SUNDRY NOTICES AND REPORTS ON WELLS
Do not use this form for proposals to drill or to re-enter abandoned well. Use form 3160-3 (APD) for such proposals.

8. Well Name and No.
MARQUARDT 1 PENN FEDERAL 3

**** BLM REVISED ** BLM REVISED ** BLM REVISED ** BLM REVISED ** BLM REVISED ****

Permanent Abandonment of Federal Wells
Conditions of Approval

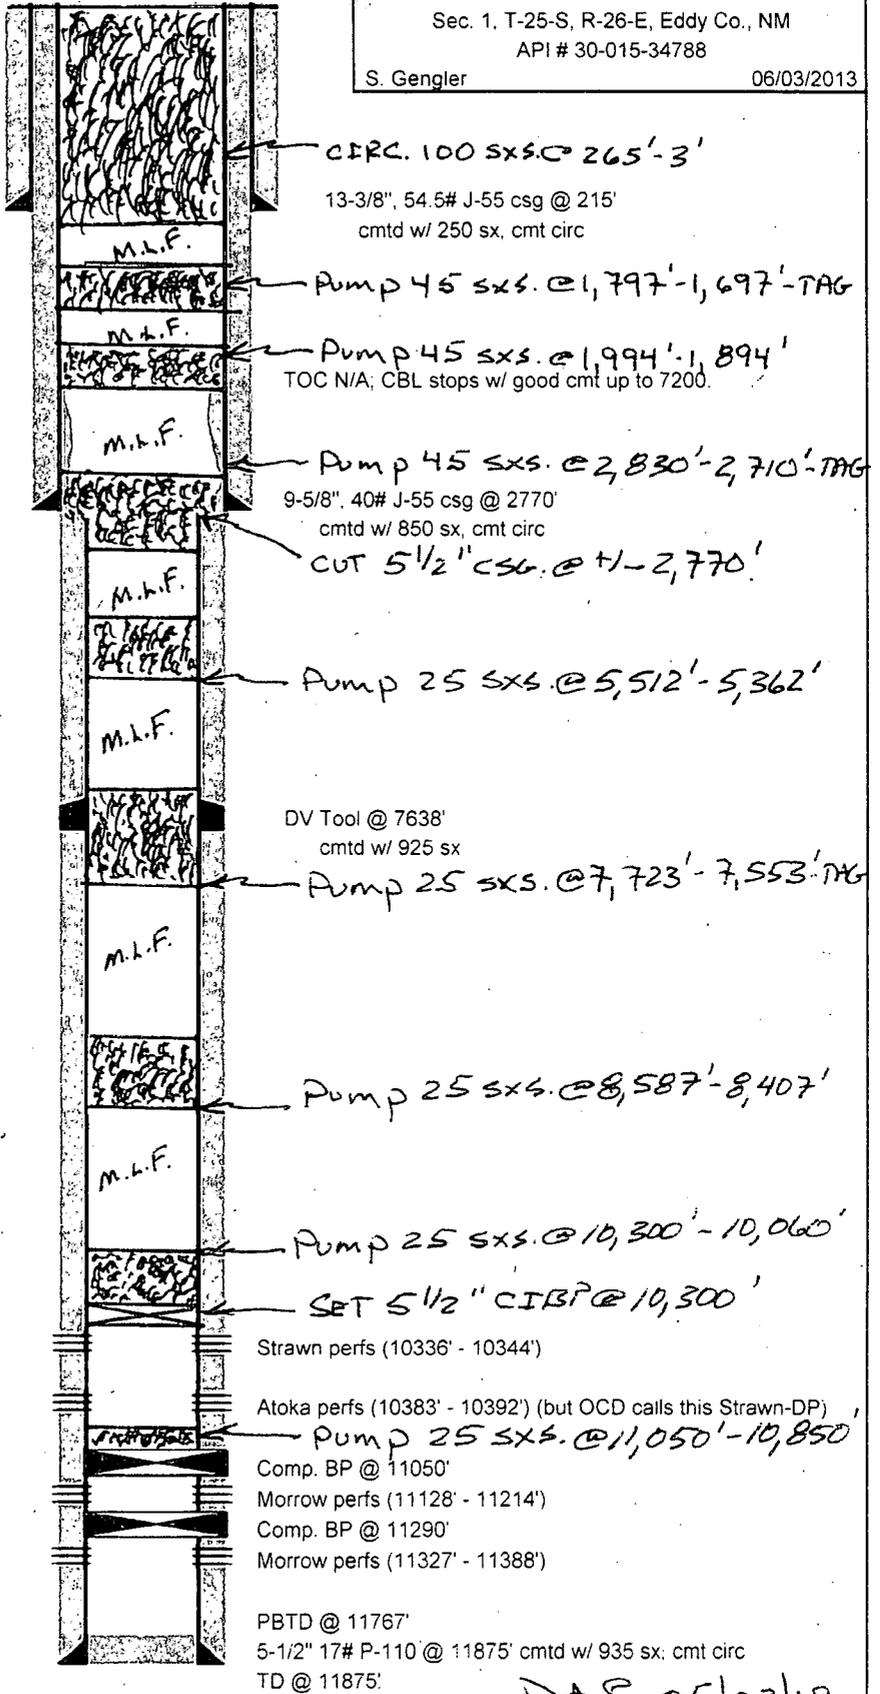
- 1) PUMP 25 SXS.CMT. @ 11,050'-10,850'(T/MRRW.). *Woc Tag to assure, Strawn Perfs not drinking Cw.*
- 2) SET 5-1/2" CIBP @ 10,300'; PUMP 30 SXS.CMT. @ 10,300'-10,060'(T/STWN.). *Add Cisco/Cyn, 25 SX from 9969. 976'*

- 3) CIRC. WELL W/ M.L.F.; PUMP 25 SXS.CMT. @ 8,587'-8,407'(T/WLCP.).
- 4) PUMP 25 SXS.CMT. @ 7,723'-7,553'(5-1/2" DV TOOL); WOC X TAG CMT. PLUG.
- 5) PUMP 25 SXS.CMT. @ 5,512'-5,362'(T/BNSG.).

- 6) ~~CUT X PULL 5-1/2" CSG @ 112,770'.~~ *Records indicate 5 1/2" 2 Stages Cine to Surf, CBL*
- 7) ~~PUMP 40 SXS.CMT. @ 2,830'-2,710'(5-1/2" CSG STUB 9-5/8" CSG SHOE);~~ *Spot Shoe plug 2820-2690. Tag*

- 8) PUMP 45 SXS.CMT. @ 1,994'-1,894'(T/DLWR.). *25 SX Depending if Cut/Pull.*
- 9) PUMP 45 SXS.CMT. @ 1,797'-1,697'(B/SALT); WOC X TAG CMT. PLUG. *25 SX Depending on cut/Pull*

- 10) MIX X CIRC. TO SURF. 100 SXS.CMT. @ 265'-3'(13-3/8" CSG SHOE).
- 11) DIG OUT X CUT OFF WELLHEAD 3' B.G.L.; WELD ON STEEL PLATE TO CSGS. X INSTALL DRY HOLE MARKER.

Get if you have something diff proceed. If not omit.
